REVISED RESPONSE TO REQUEST FOR ADDITIONAL INFORMATION

APR1400 Design Certification

Docket No. 52-046

RAI No.: 182-8160
SRP Section: 03.07.01 – Seismic Design Parameters
Application Section: 3.7.1
Date of RAI Issue: 08/31/2015

Figure 1 Northridge Earthquake Time History, E-W Direction

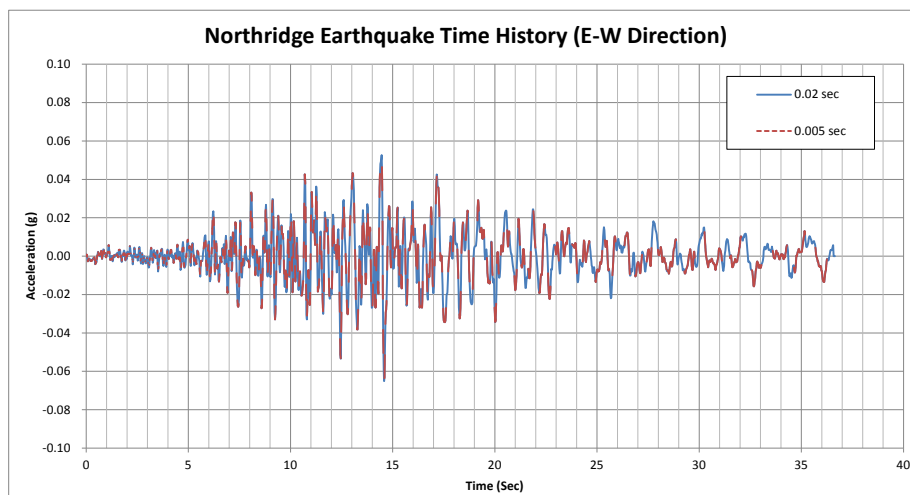
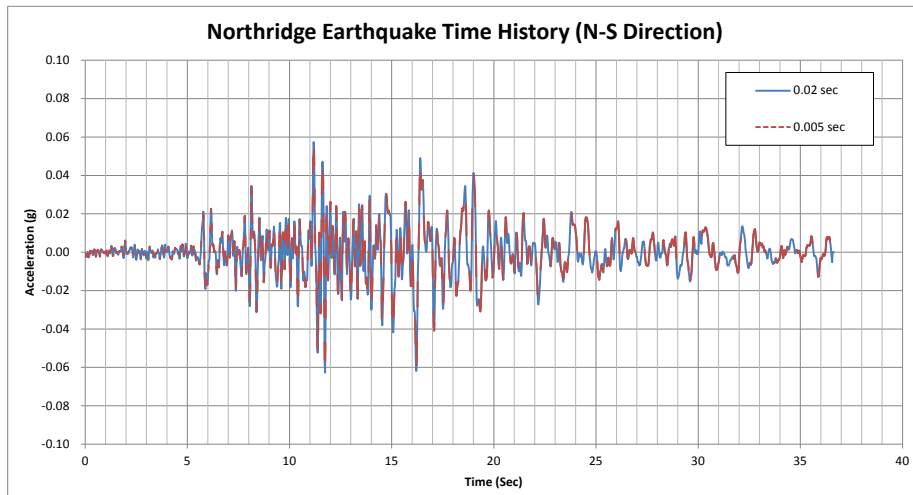
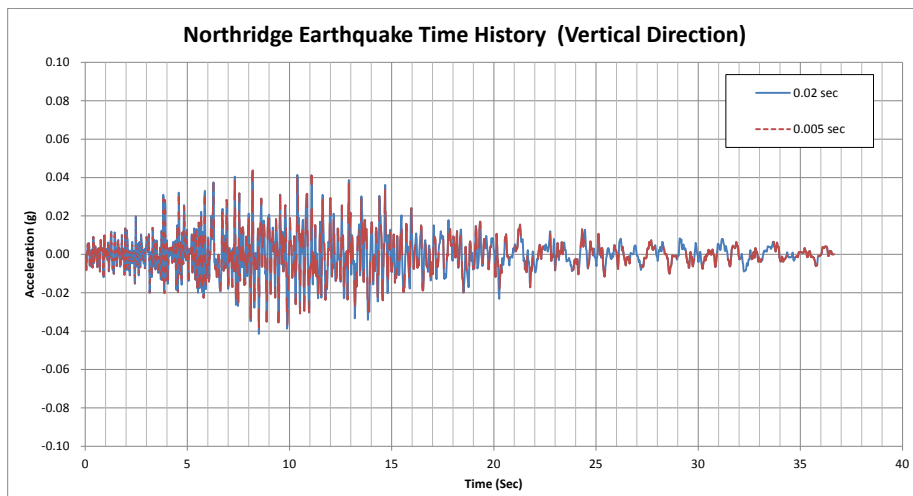
As described in Section 3.2.2 of APR1400-E-S-NR-14001-P, Rev. 0, the recorded seed time histories, from the M6.7 Northridge earthquake, has a time increment of 0.02 s, which corresponds to a Nyquist frequency of 25 Hz. Furthermore, Figures 3-4 and 3-5 of this technical report show that the frequency contents are only up to about 8~9 Hz for the two horizontal directions. However, Section 3.2.3 of this technical report

indicates that the applicant re-digitized the time histories to 0.005 s. Therefore, the applicant is requested to (1) provide a description and a justification of the method used for the re-digitization of the seed recorded time histories, and (2) provide an explanation why the seed recorded motions for the two horizontal directions are considered acceptable given that they have power only up to 8~9 Hz (not to 50 Hz).

Although these recorded motions are recorded motion for WUS and have a time increment (Δt) of 0.02 seconds, which corresponds to a Nyquist frequency of 25 Hz, they can be used for response spectrum matching for response spectra with a cutoff frequency higher than 25 Hz. This is discussed in NUREG/CR-6728, Section 3.4 - Matching WUS Time History to CEUS Spectrum, in which it states in the second to the last sentence on Page 3-6 that “Overall, these comparisons indicate that WUS motions can be used as inputs to matching CEUS spectra provided the sample interval reflects a Nyquist frequency ($f_N = [2 \Delta t]^{-1}$) of at least 100 Hz.” Thus, to make the selected seed motions suitable for inputs to match CSDRS, which has spectral cutoff frequency at 50 Hz, the recorded seed motions need be re-digitized to have a time increment (Δt) of 0.005 seconds so that the Nyquist frequency is 100 Hz, as discussed in NUREG/CR-6728, Section 3.4 - Matching WUS Time History to CEUS Spectrum, mentioned above. The re-digitization of time histories with a time increment of 0.005 seconds is performed using linear interpolation of the time histories recorded at 0.02 second intervals. The comparison of time histories digitized in time increment of 0.02 seconds and 0.005 seconds is shown below in Figures 1 through 3.
